# HIGHLANDS SUBDIVISION

## FINAL SITE PLAN AND SUBDIVISION APPLICATION

JANUARY 21, 2020  
REVISED APRIL 15, 2020

DATE: 3/15/2019  
SCALE: 1"=40'  
DESIGNED: JDA  
JOB NO: 1804  
FILE: 1804 S.DWG  
SHEET **C-3.0**

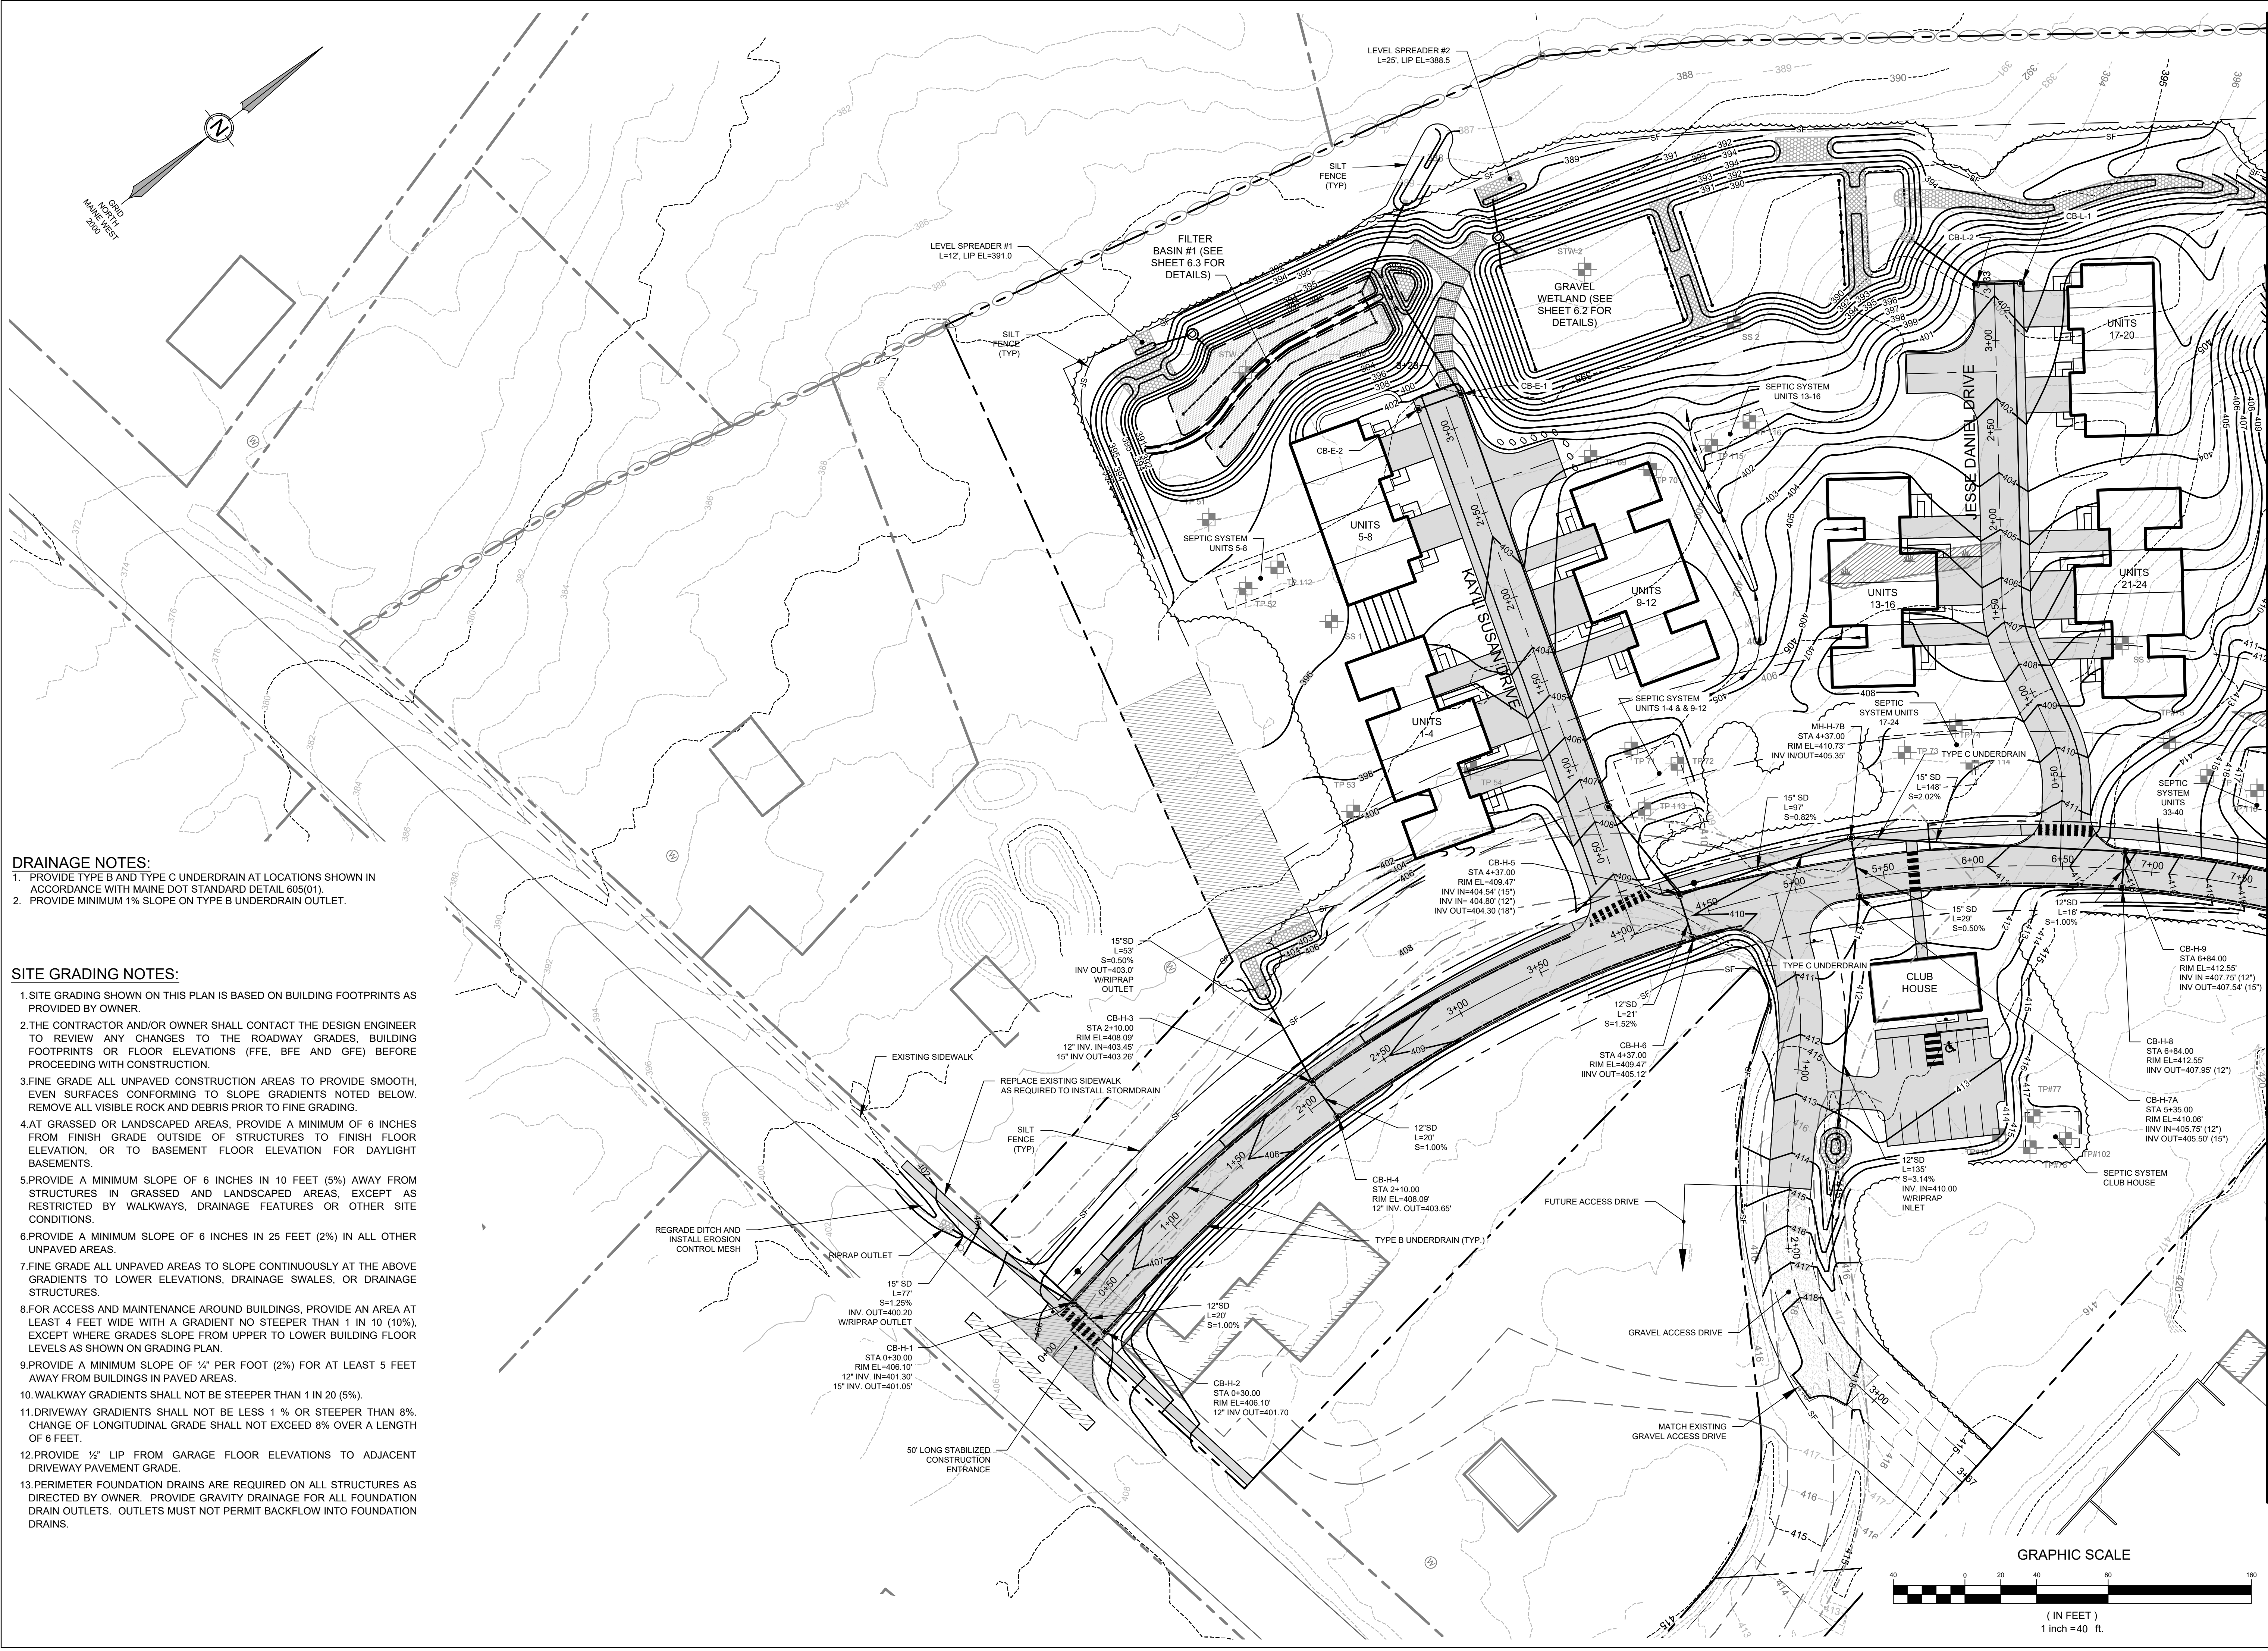
- Underdrain as shown on the Typical Road Sections (sheet C- 6.0) should be shown on all the Grading Plans, (sheets C-3.0 through C-3.7).

*Comment 14: Sheet C-3.0 - CB-H-7B is located in a sidewalk – should be a drain manhole.*

*Response: Notes requiring Type B 6" underdrain and Type C underdrain are added to Sheet C-3.0.*

SHEET **C-3.1**

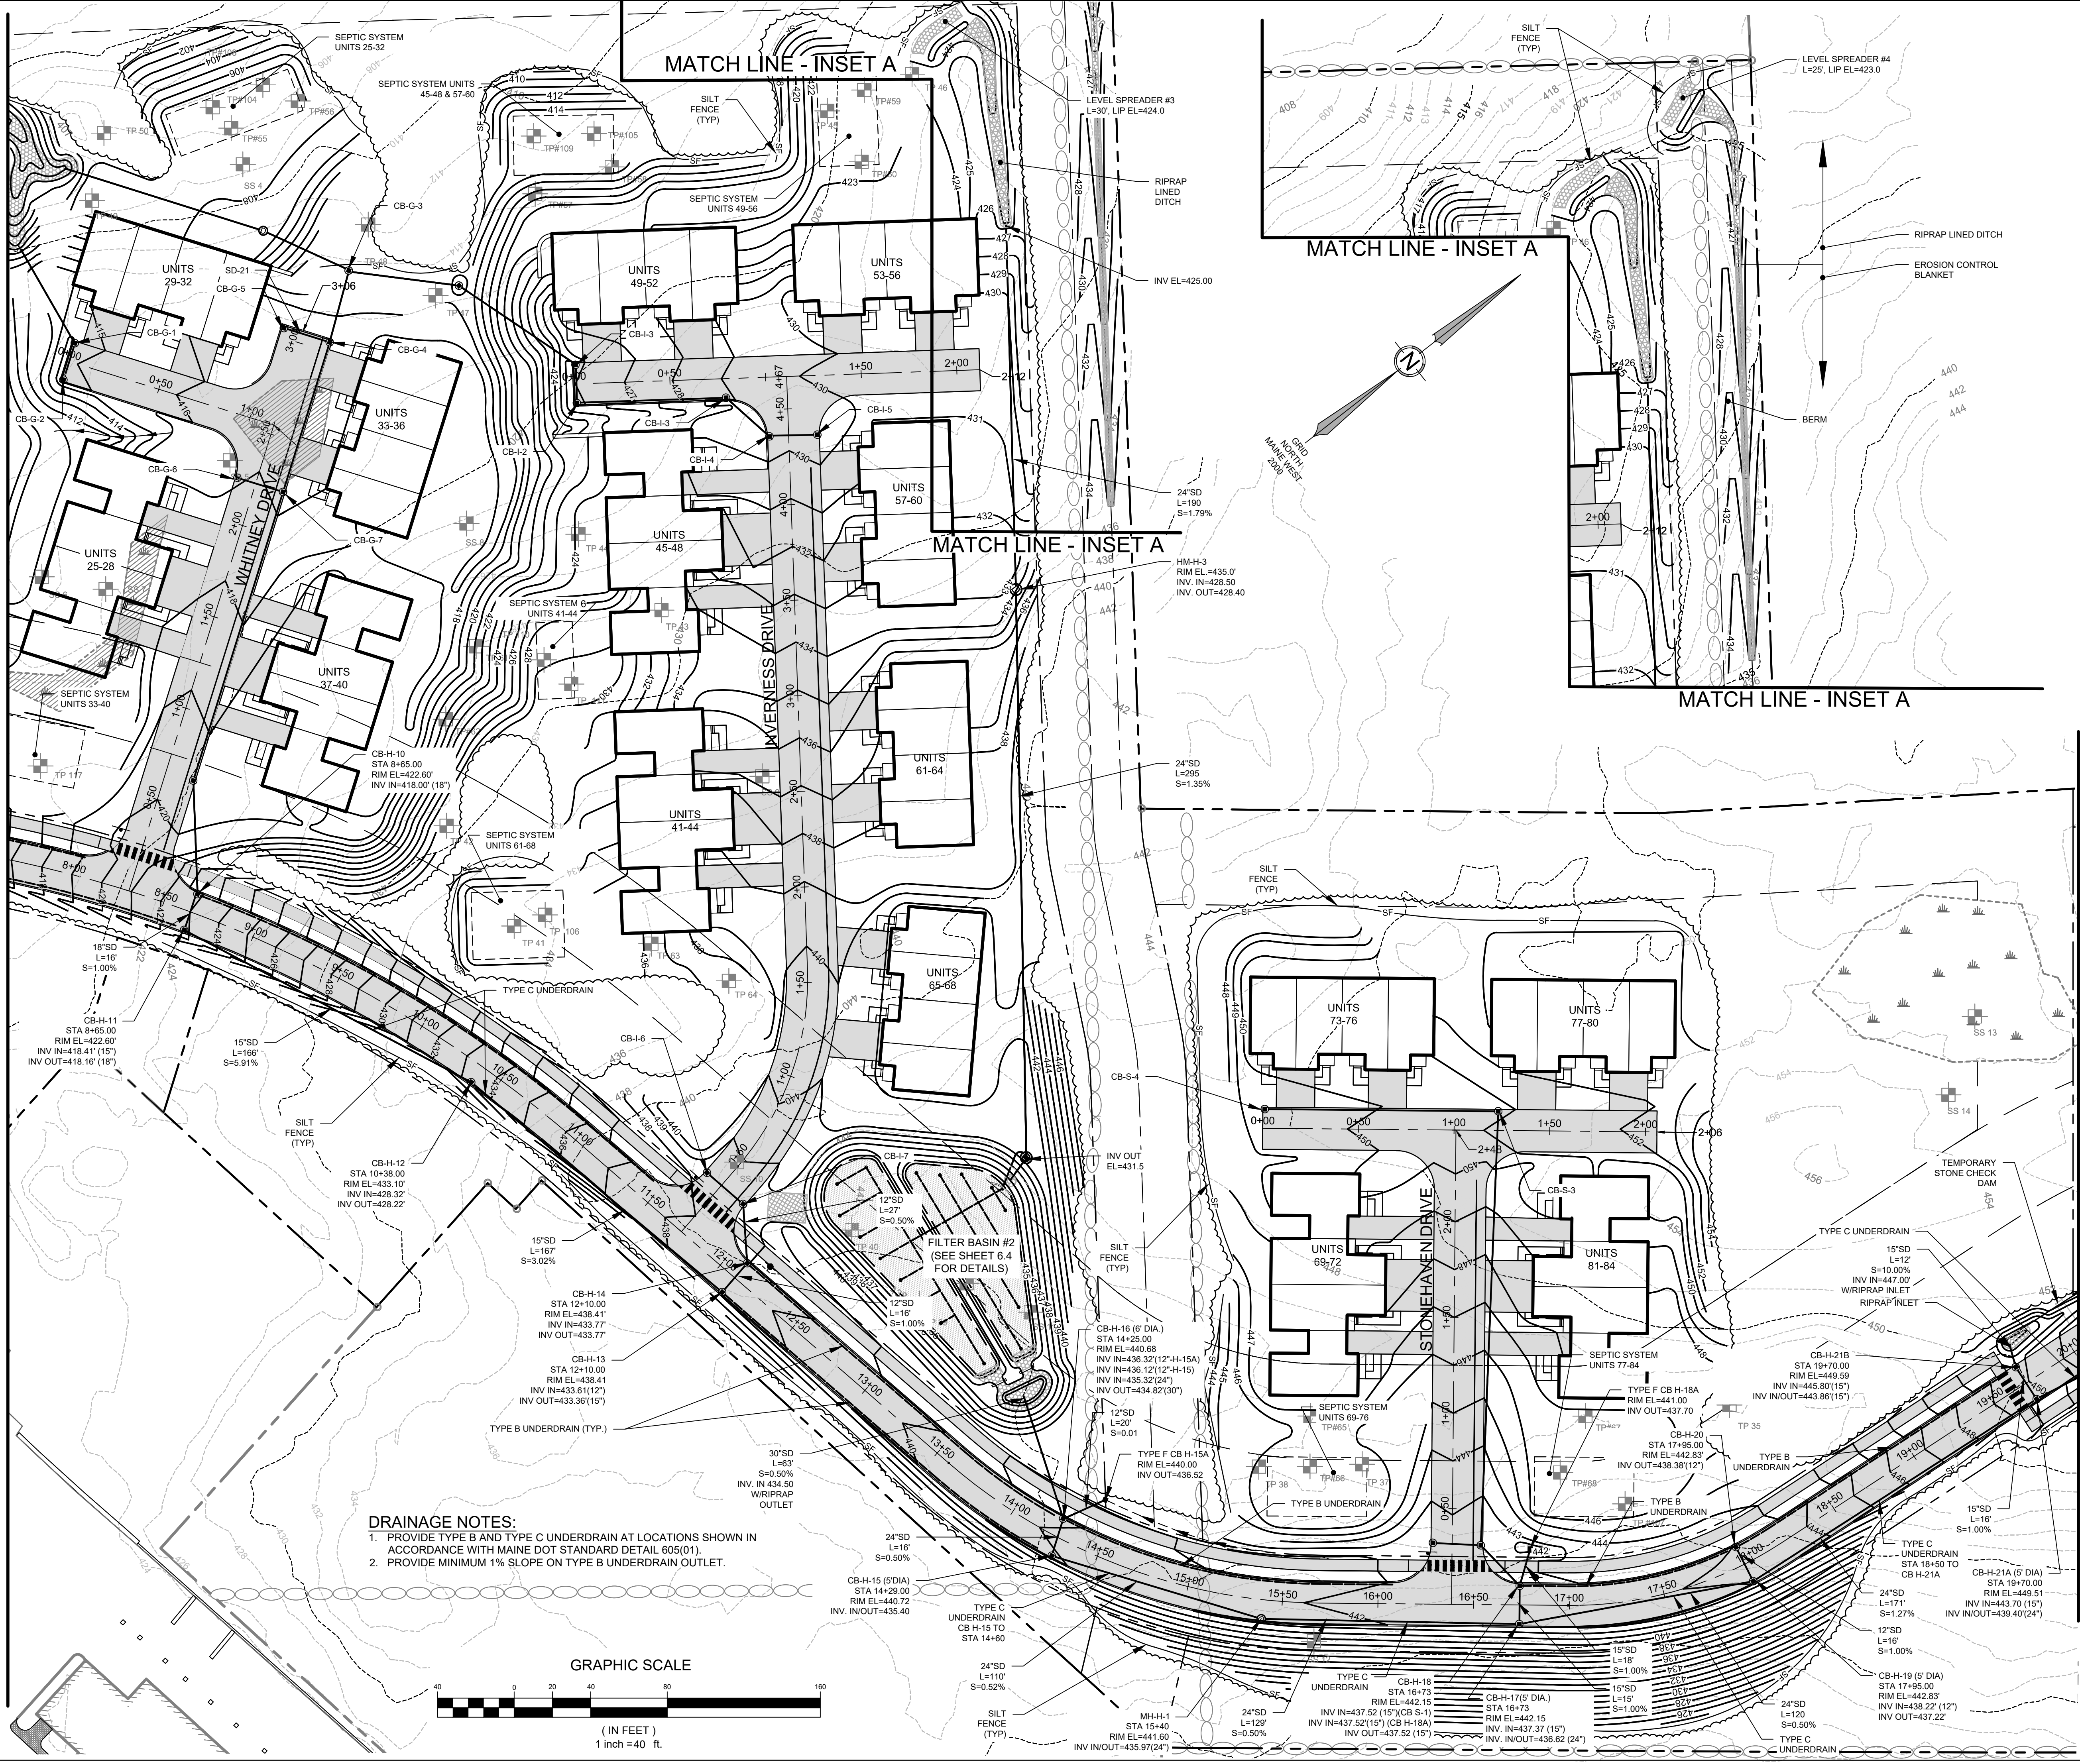
*Comment 15: Sheet C-3.1 – CB-H-12 – Invert elevation out is higher than invert in. CB-H-19 – Invert out is higher than next downstream structure.*

DATE:	3/15/2019
SCALE:	1"=40'
DESIGNED:	JDA
JOB NO:	1804
FILE:	1804 S.DWG
SHEET	<b>C-3.3</b>

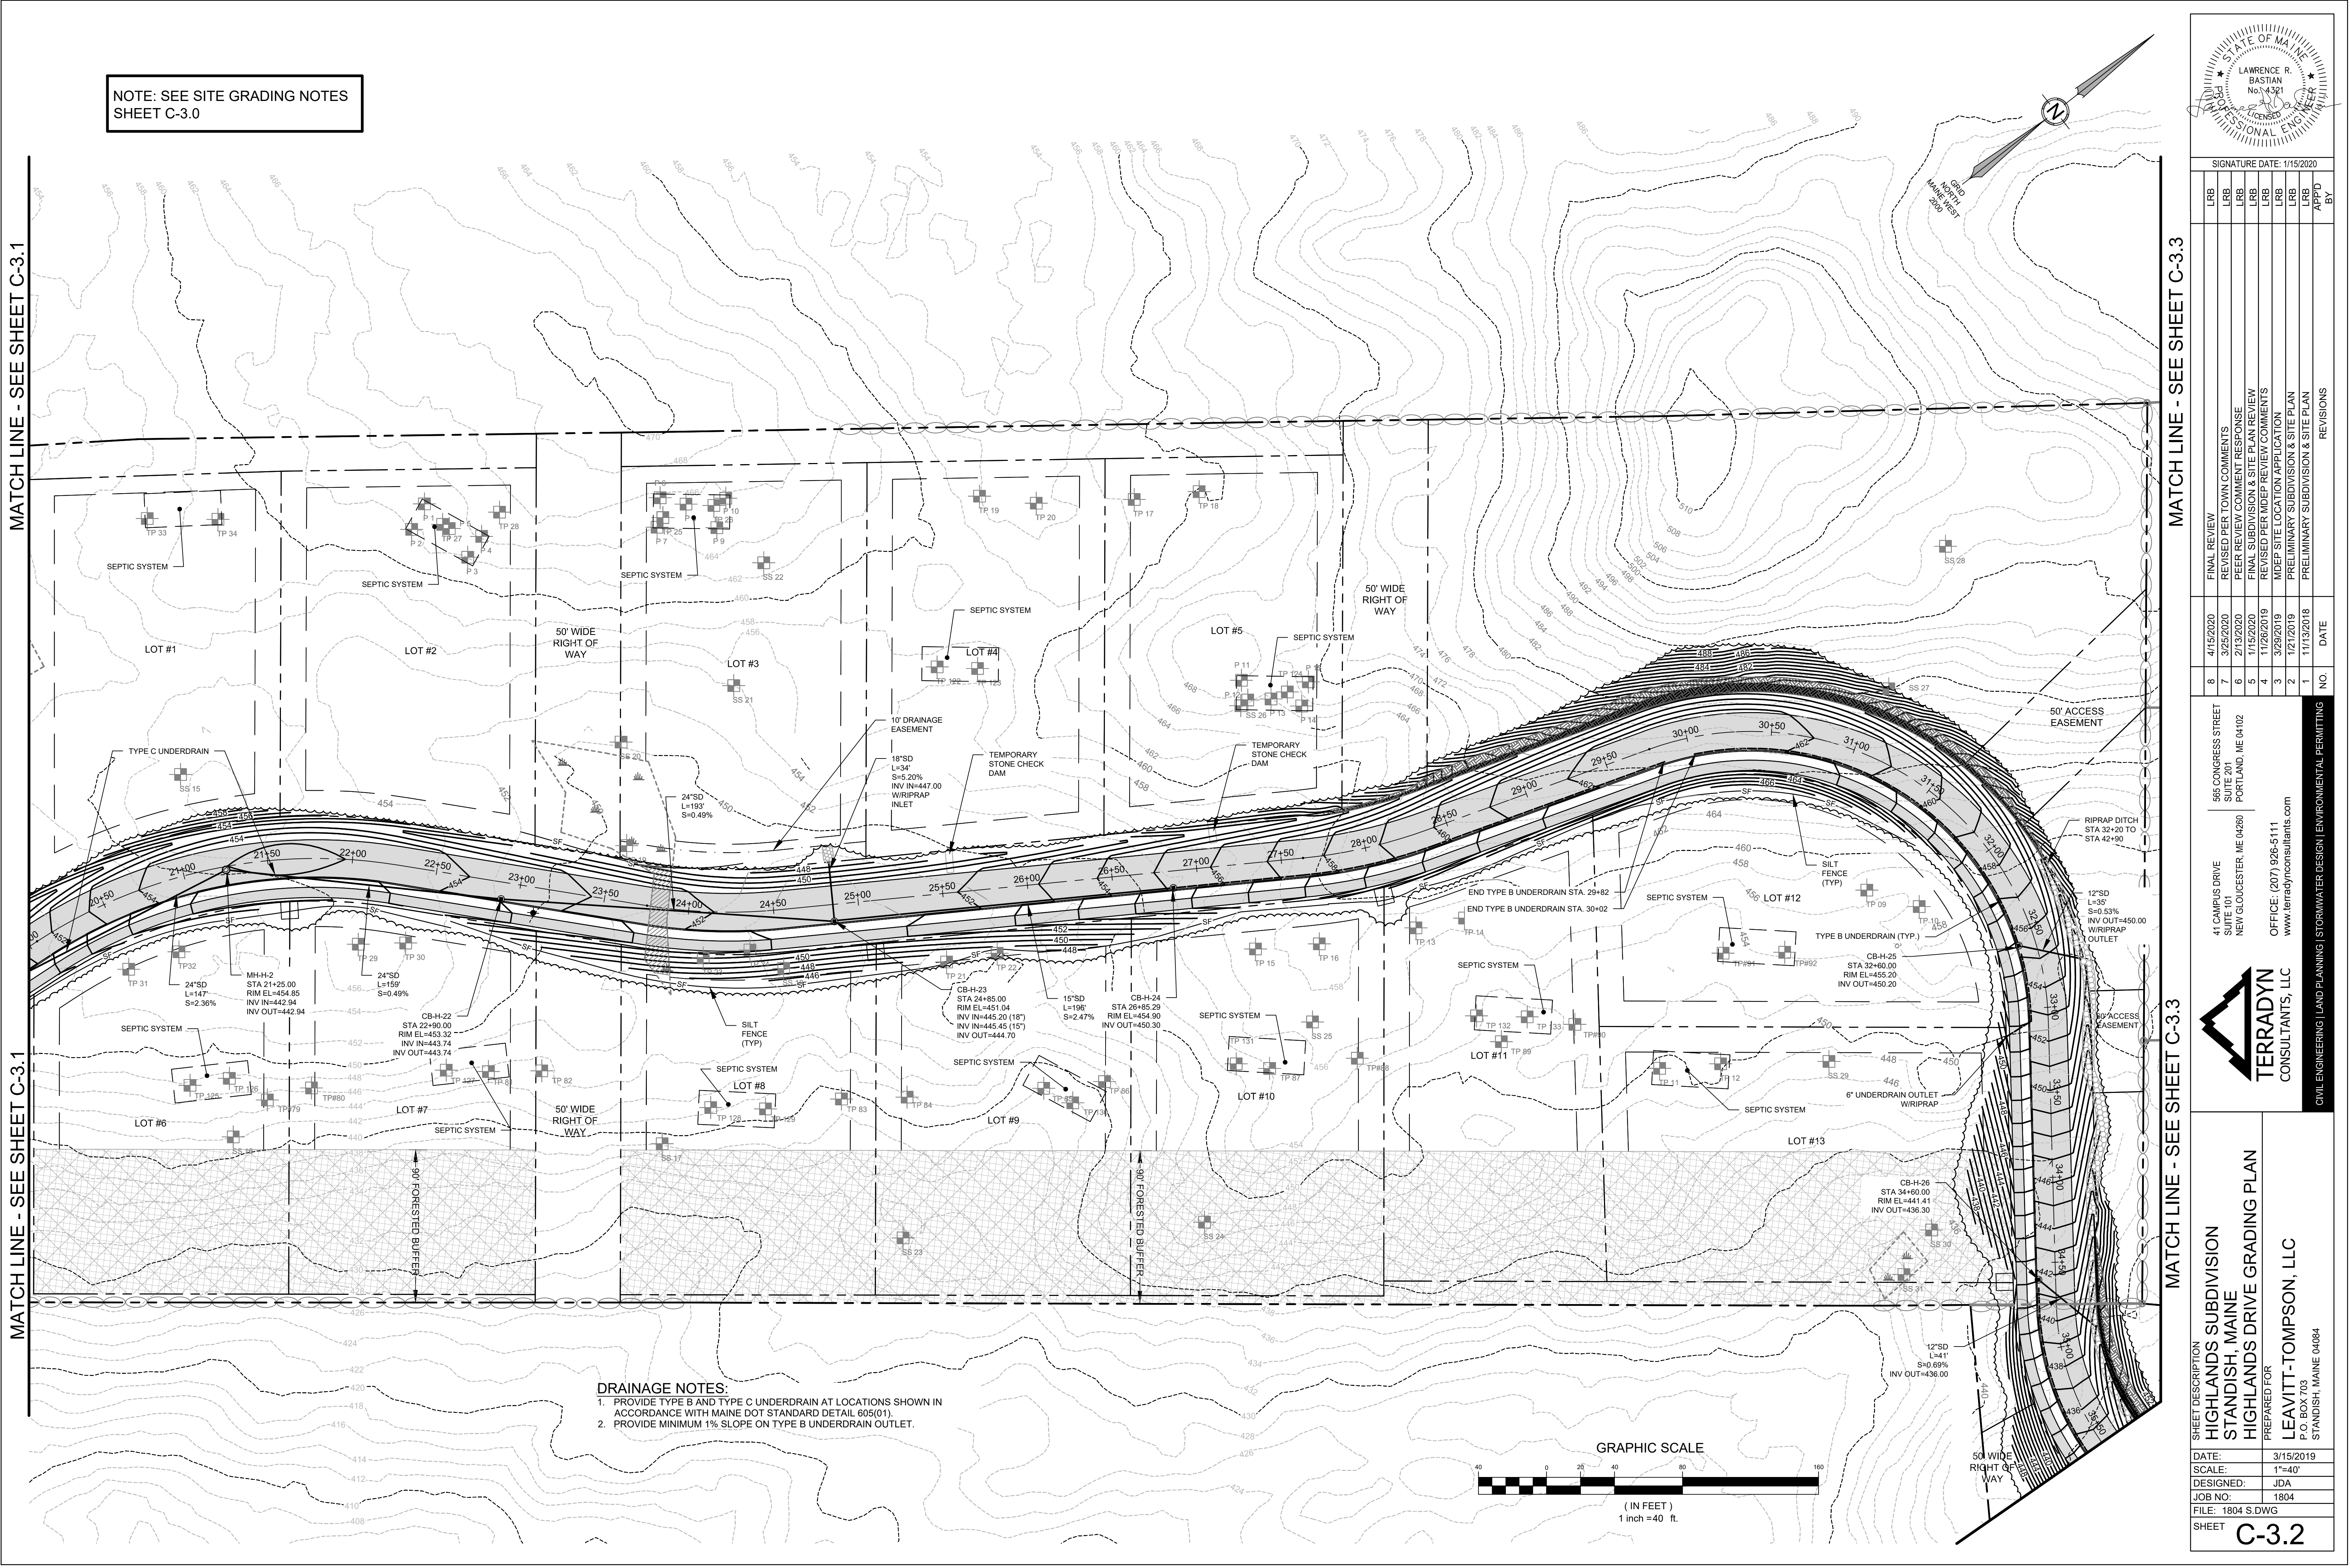
- The traffic report recommends minor re-shaping of the Oak Hill road ditch to the left of the intersection (in front of 130 Oak Hill Road) to improve sight distance. That re-grading should be shown on Sheet C-3.3.

10. *Footprints of proposed subsurface wastewater disposal fields at the 18 single-family subdivision lots should be shown on site plans C-3.2 and C-3.3. See Part II, Section 17.A.1 of the site application. Depending on soil conditions or proposed field design at any lot, more than one TP may be required within the footprints, as outlined in Part II, Section 17.A.4 of the site application. Note that there are areas of shallow-to-bedrock soil at lots 2, 3, 5, 14, and 15 that will need additional TP data per Section 17.A.4.a if those areas are selected for a disposal field.*

*Comment 16: Sheet C-3.3 – It appears grassed swale on Lot 18 should be in a drainage easement.*

Response: Disposal field footprints and test pits are now shown on sheets C-3.2 and C-3.3.
